Project	IEEE 802.16 Broadband Wireless Access Working Group < http://ieee802.org/16 >	
Title	MS CDMA-based BR in Non-transparent RS System under Centralized Scheduling	
Date Submitted	2006-03-15	
Source(s)	<p>Kanchei (Ken) Loa, Yi-Hsueh Tsai, Chih-Chiang Hsieh, Yung-Ting Lee, Hua-Chiang Yin, Shiann-Tsong Sheu, Frank C.D. Tsai, Youn-Tai Lee, Heng- lang Hsu Institute for Information Industry 8F., No. 218, Sec. 2, Dunhua S. Rd., Taipei City, Taiwan.</p> <p>Masato Okuda Fujitsu Laboratories LTD. Kamikodanaka 4-1-1, Nakahara-ku Kawasaki, Japan. 211-8588</p> <p>Yousuf Saifullah, Shashikant Maheshwari Nokia 6000 Connection Drive, Irving, TX</p> <p>Kerstin Johnsson Intel Corp. 2200 Mission College Blvd. Santa Clara, CA 95054</p> <p>Changkyoon Kim Samsung Thales San 12-1, Nongseo-Dong, Giheung- Gu, Yongin-City, Gyeonggi-Do, Korea 446- 712</p> <p>Chie Ming Chou ITRI/NCTU</p> <p>[add co-authors here]</p>	<p>Voice: +886-2-2739-9616 loa@iii.org.tw</p> <p>Voice: +81-44-754-2811 Fax: +81-44-754-2786 okuda@jp.fujitsu.com</p> <p>Voice: 972 894 5000 yousuf.saifullah@nokia.com shashikant.maheshwari@nokia.com</p> <p>Voice: +1-408-653-9651 kerstin.johnsson@intel.com</p> <p>Voice: +82 31 280 9919 Fax: +

[Figure <XXX> BW request/allocation signaling in centralized scheduling](#)

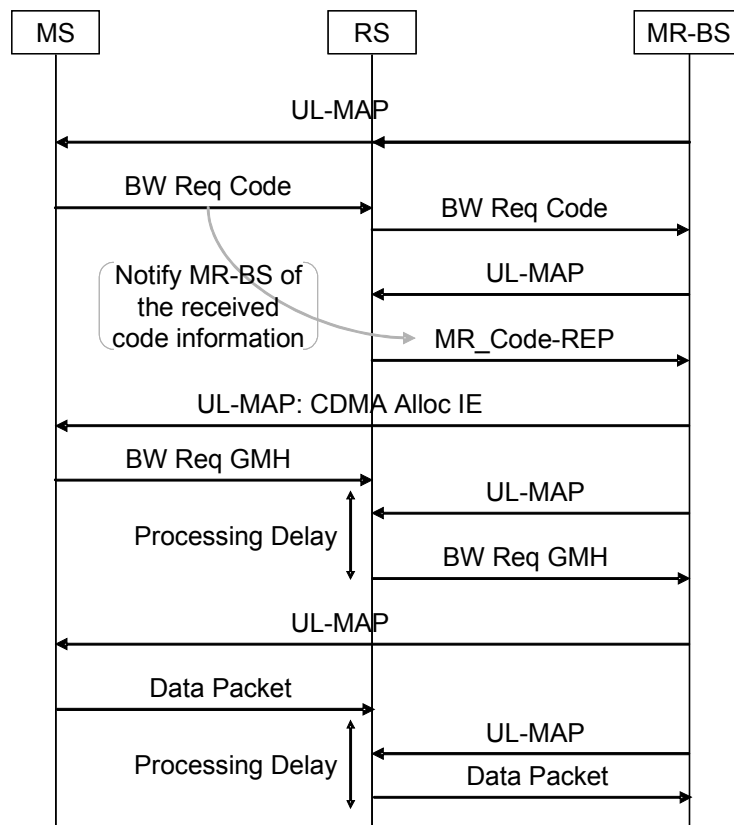
Add the following sentence and Figure after the second sentence of the third paragraph in 6.3.6.7.2.1

Thus, when an RS receives a BW request CDMA ranging code from one of its SSs, it shall send the appropriate RS CDMA ranging code toward the MR-BS indicating that one of its SSs is requesting to forward a BW request header to the MR-BS. Each intermediate RS along the path to the MR-BS relays this code in the uplink direction. Upon receiving this code, the MR-BS shall respond by ~~creating the appropriate downlink and uplink allocations~~ allocating uplink bandwidth to the RS along the relay path so that the RS can send the MR-Code-REP message to the MR-BS. CDMA code information in the MR_Code-REP is used by the MR-BS to generate UL-MAP allocating uplink bandwidth to the MS. Please see the figure <XXX>.
